**Application no: 23/01493/REM**

**Location:** Proposed Himley Village North West Bicester, Middleton Stoney Road, Bicester

### Transport Schedule

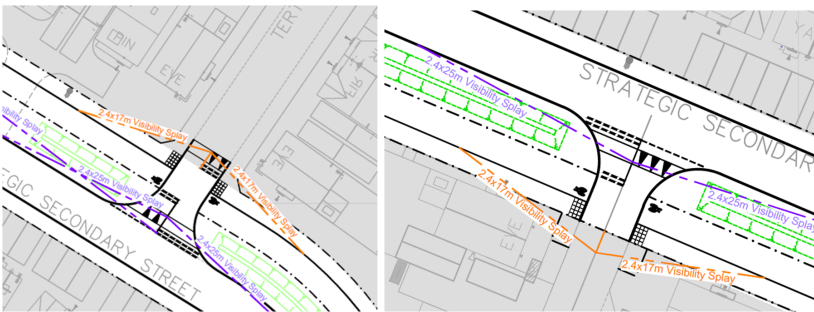
It was noted that some visibility splays are located outside the red line boundary (see below). All visibility splays need to be within the red line boundary.

Hydrock to update red line to include visibility splays and switch off layer that shows the houses outside of the red line boundary.  
Show all adoptable areas on Phase 1B layout.

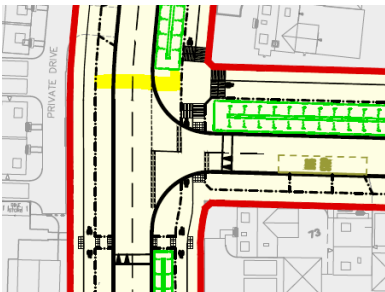
The cycle crossing over the Spine Road North -South to connect to the Spine Road East-West has not been included. We suggest that a crossing is included at the location in yellow below.

Move cycle crossing point at north down to requested location in yellow above along the desire line. Copy arrangement at eastern parcel.  
OCC Highways agreed cyclists won't have priority along this junction. ▲

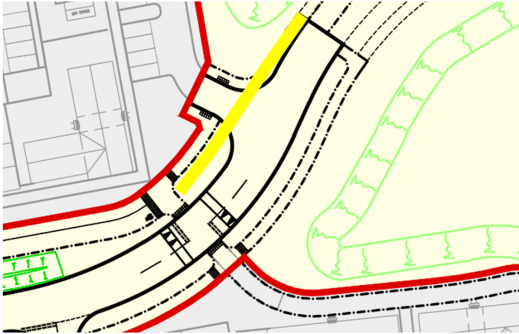
A raised cycle priority crossing is required at the eastern end of the Spine Road East-West for cyclists to be able to access the next phase of the development.

Change to a raised cycle priority crossing replicating the raised table on the western parcel.  
Drainage basin to be tweaked in Drainage Strategy plans.

East West Spine Road

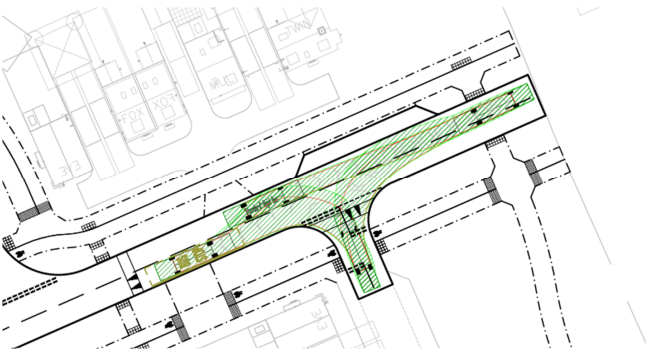
The temporary bus turning heads are not acceptable as it will require buses reversing over the raised cycle crossings which is considered a safety issue. In addition, all wheels will need to face forward and not be at an angle at the turn. Specifically designated independent turning heads should be constructed for buses to be able to turn.

OCC Highways agree that we won't build a raised table for the time being and have bollards and signs for a temporary arrangement for a bus. Have a condition attached to the RM approval to say once turning head is not needed the raised table will be constructed.

Hydrock to do a separate plan for condition to be attached to.

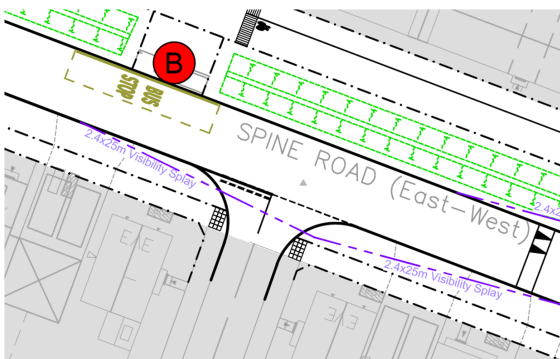
The visibility crosses the bus shelter on the Spine Road North- South. Visibility splays should be clear of obstruction.

Remove / adjust location of VP spaces. Check bus shelters aren't in visibility splays.

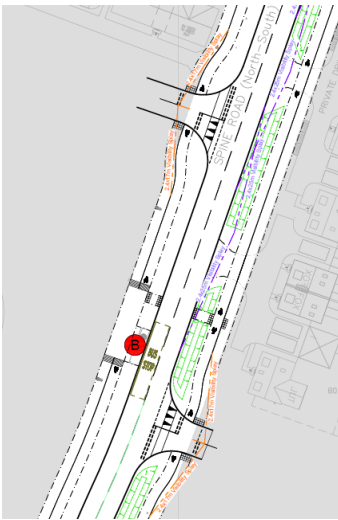
At a number of locations, the visibility splays do not commence in the centre of the side road and are therefore in the incorrect location.

Vehicle visibility has not been demonstrated for the care home access and the local centre access.

Hydrock to check all visibility splays within Phase 1B to ensure they are demonstrated and are from the centre of the roads.
